## **SWEENEY BLOCKS**

4440 FAUNTLEROY AVE SW, SEATTLE WA 98126  
SDCI Project #3035693-LU | RECOMMENDATION | Meeting Date: November 18, 2021

Massing

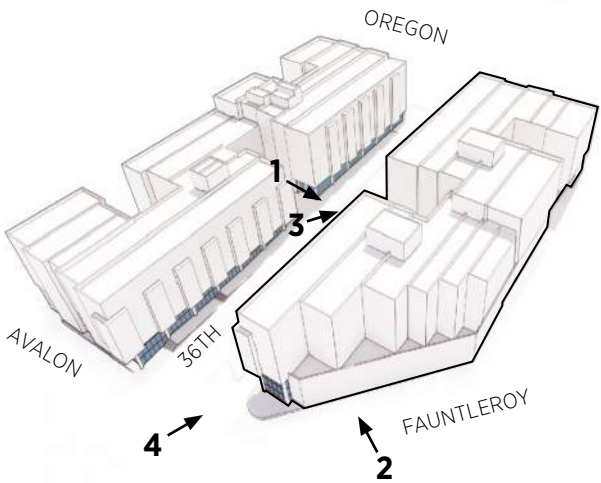
- a. The Board supported the applicant’s preferred massing, Option 3, and discussed how Option 3’s massing could be improved.
- b. The Board, while they supported the applicant moving forward with Option 3, requested the applicant create a difference between this site and the site to the east. The Board encouraged the applicant to further the design so that this building design stand on its own and not replicates or mimics too closely the design of the proposed building immediately east of the site.

While the West building shares a similar root concept with the East building, the sites are quite different. The design team has worked to differentiate the West building with the following series massing changes and additive elements that respond to specific site conditions:

- 1. Stepped massing at the courtyard corner
- 2. Unique street edge along Fauntleroy
- 3. Unique residential entry pavilion
- 4. Specialized treatment of the North corner retail

These massing elements help create a unique location identity for the West building.

REVISED STREET DESIGN:

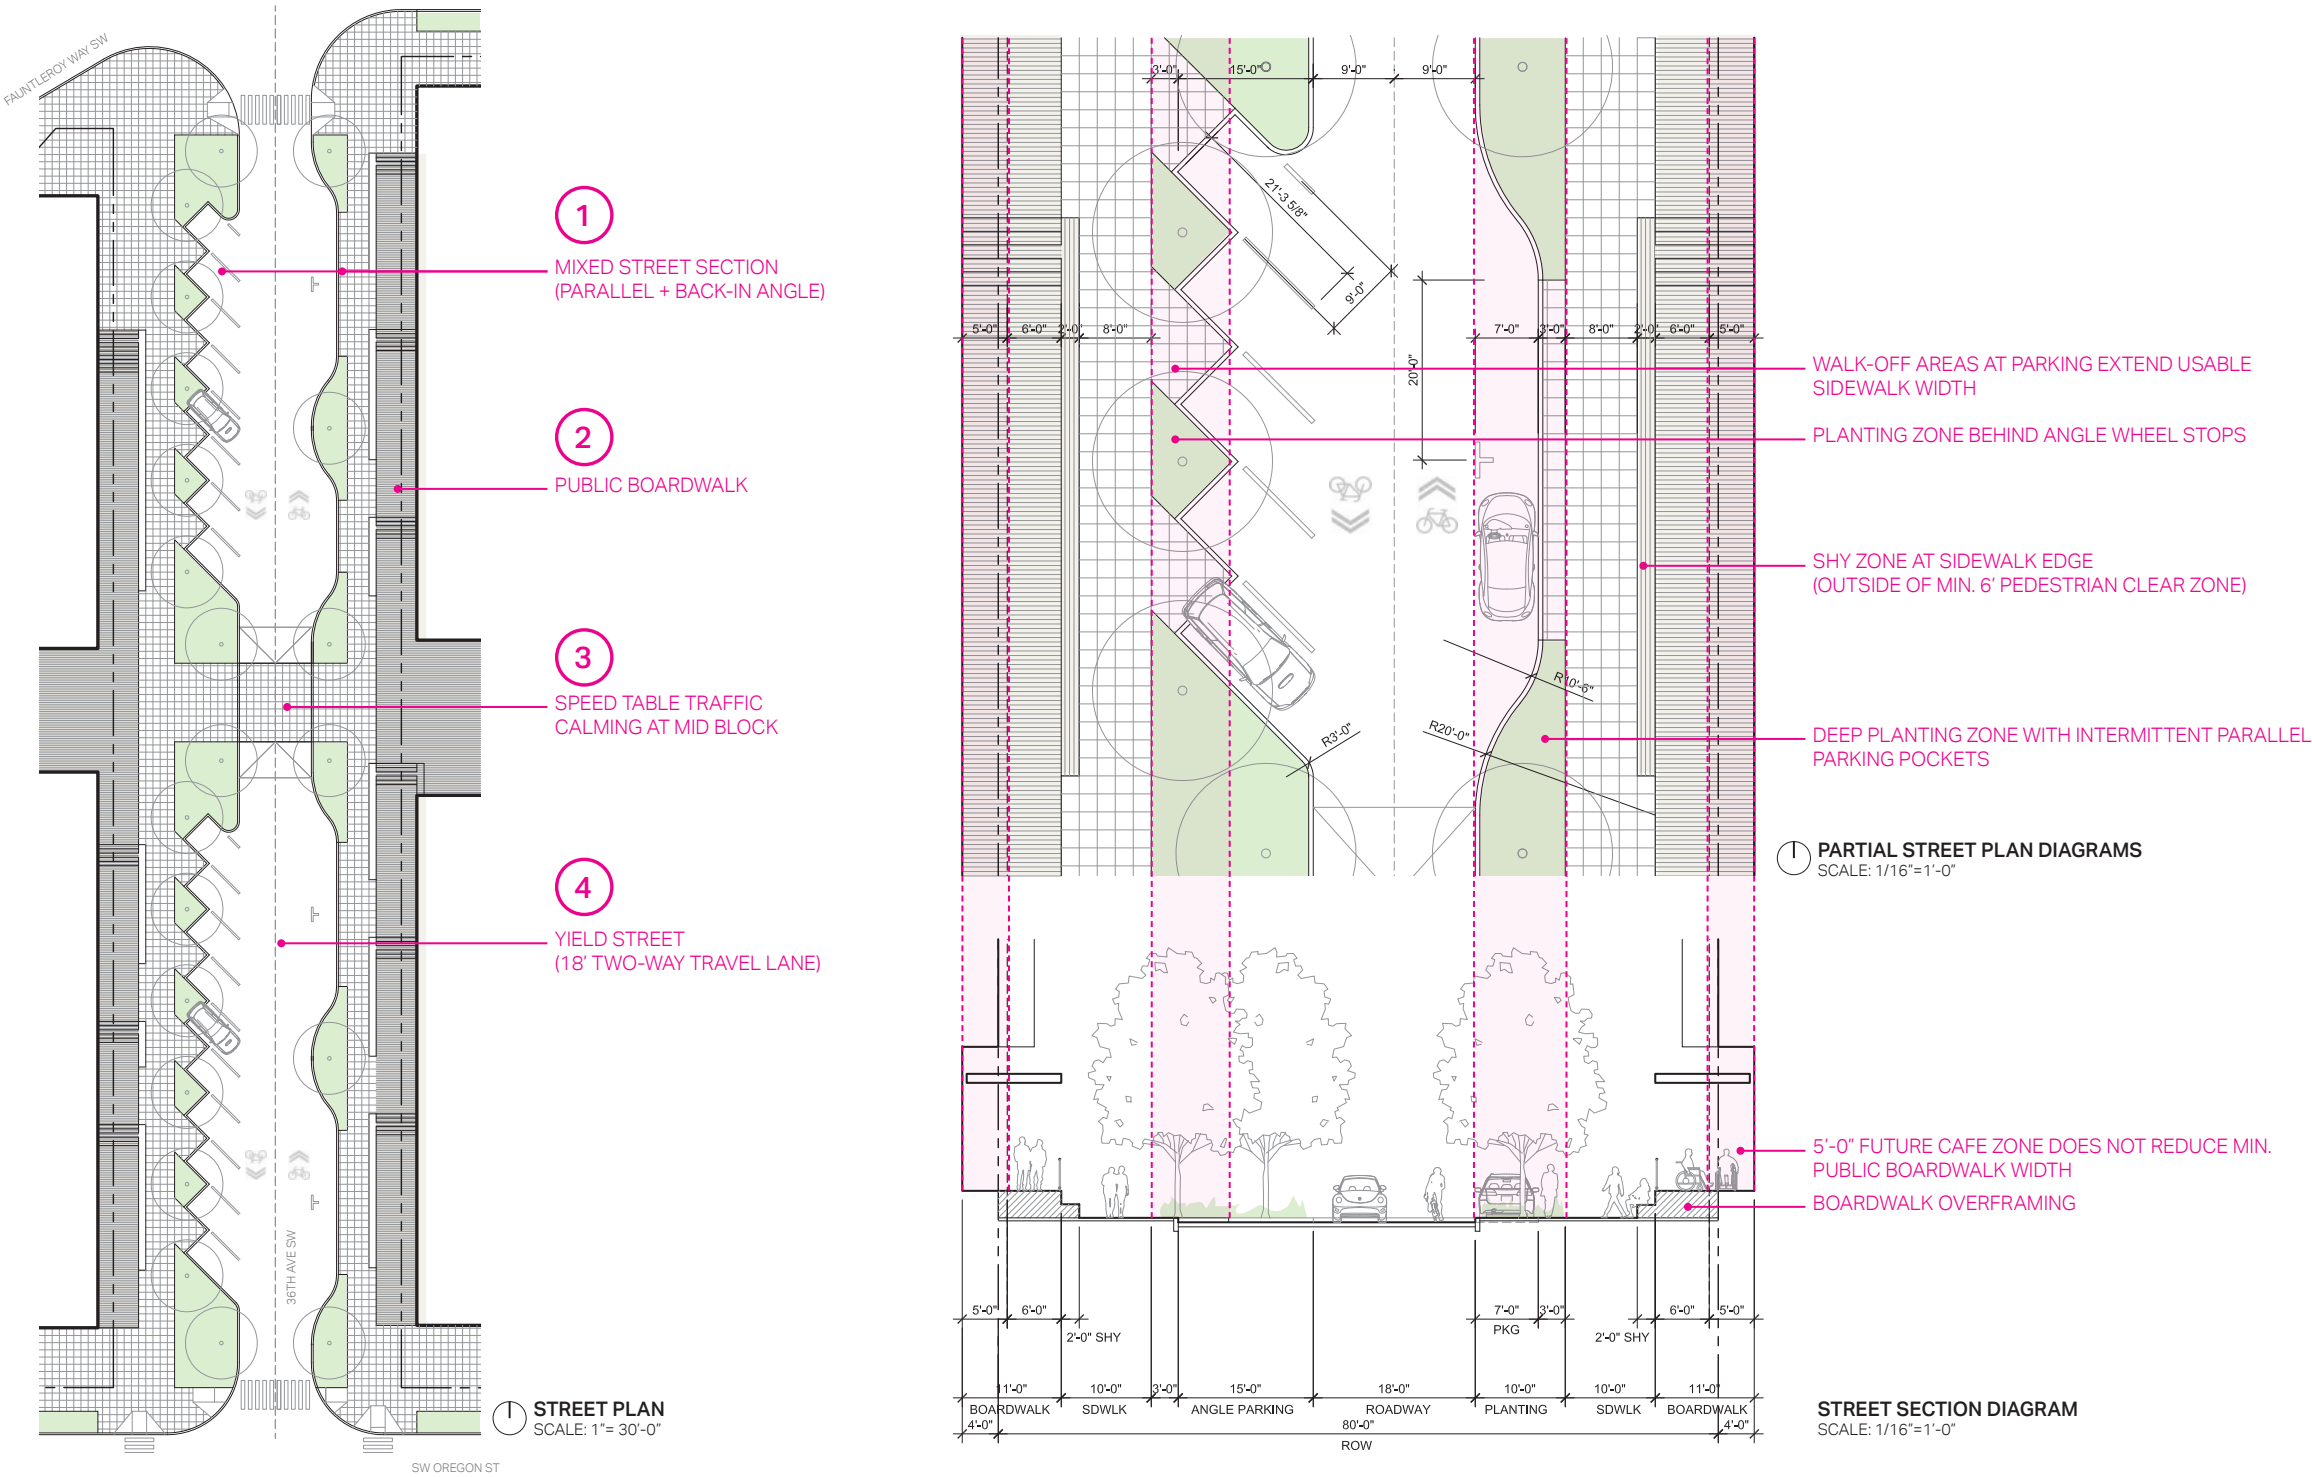
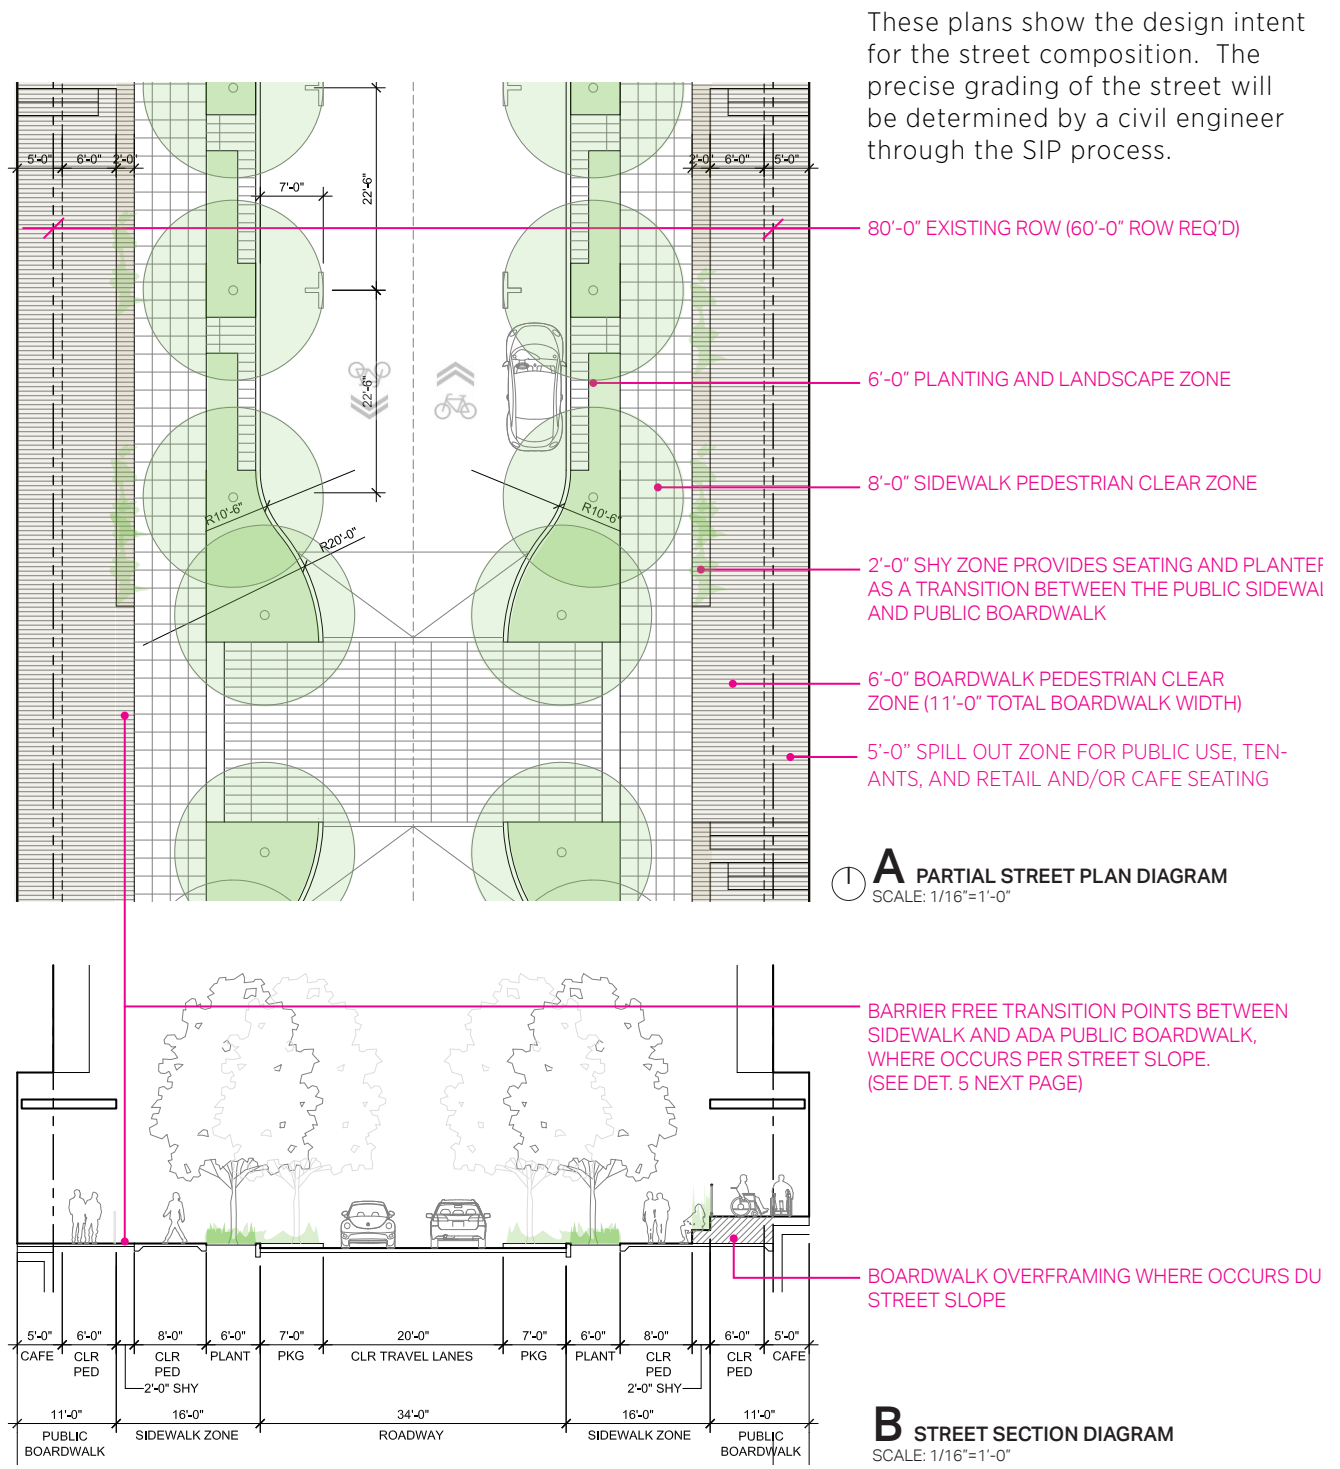
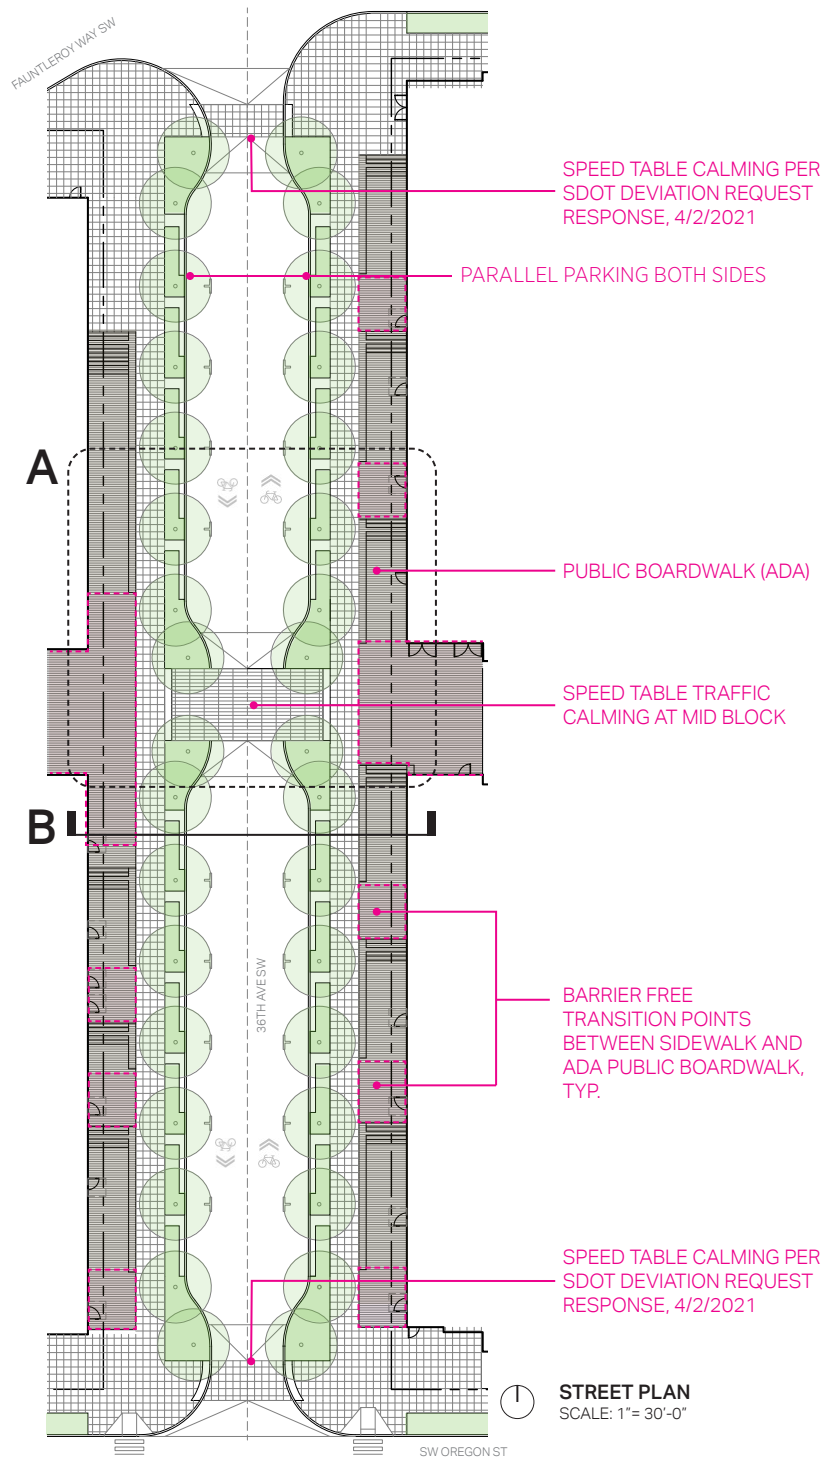
f. Echoing public comment, the Board was inclined to support the upgraded 36th Avenue SW street design presented to them at the meeting, understanding that the final review and approval lies with SDOT. The Board supported the proposed speed table at the mid-block crossing and the yield street design. With 9-foot travel lanes of the yield street design, the Board noted this allows for wider sidewalks. The Board acknowledged that SDOT will determine if a mid-block crossing for pedestrians is permitted, however, the Board noted that providing the street level design and infrastructure to support such a crossing could eventually lead SDOT to warrant a pedestrian crossing at the mid-block location. The Board members stated support for a pedestrian designed street as appropriate in this area based on the future light rail service and light rail station planned for the neighborhood. The Board requested that alternative studies be provided in the recommendation packet to illustrate the street level and building designs should SDOT not approve the street plans presented to the Board.

The street-level design of 36th Avenue has continued to develop in conjunction with SDOT. A number of improvements have been made to accommodate future consideration of the boardwalks. At this time there is no path to approve the boardwalks prior to SIP. In this package we show the boardwalks as the preferred option but illustrate how the building would work without them. In all cases the boardwalks would be constructed with removable elements.

BOARDWALK STUDIES

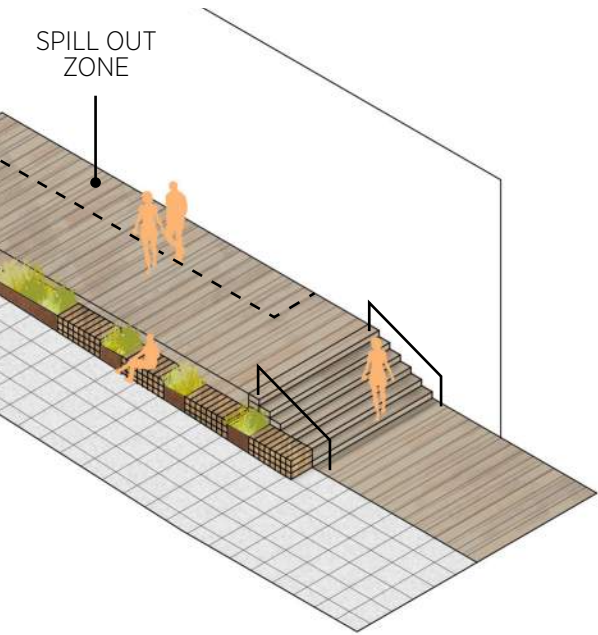
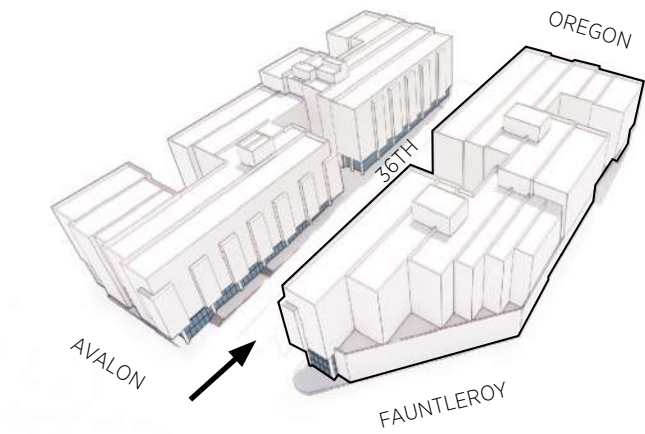
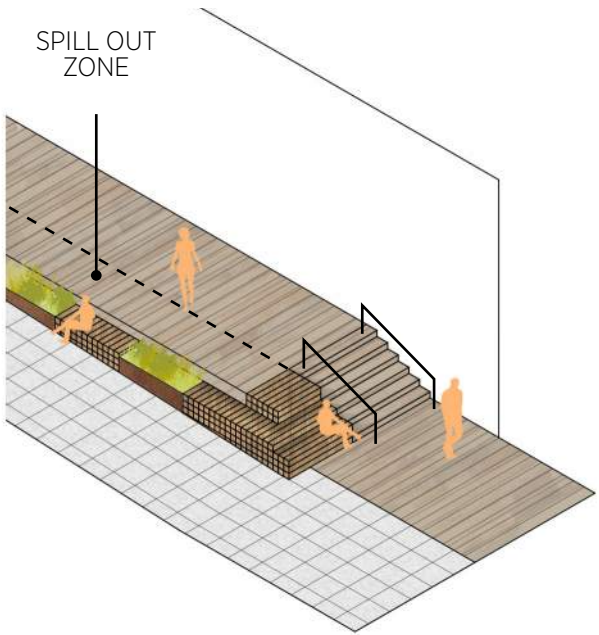
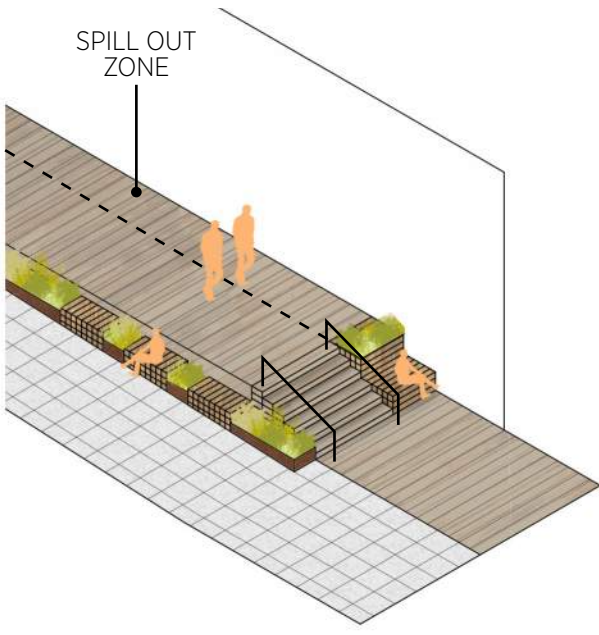
a. The Board requested the applicant further develop the street level design to create a highly pedestrian friendly street level.

36th has been the subject of ongoing dialog with SDOT. In coordination with SDOT we are proposing the following design features to accommodate multi-modal access and provide generous opportunities for pedestrian activity:

- Reduced roadway width
- Back-in angle in parking removed
- Speed tables at Avalon, mid-block and Oregon
- 8' sidewalk + 6' dedicated walkway on boardwalk
- 5' spill out zone
- 2' shy zone between the boardwalk and the sidewalk
- Design is compatible with neighborhood bike plan
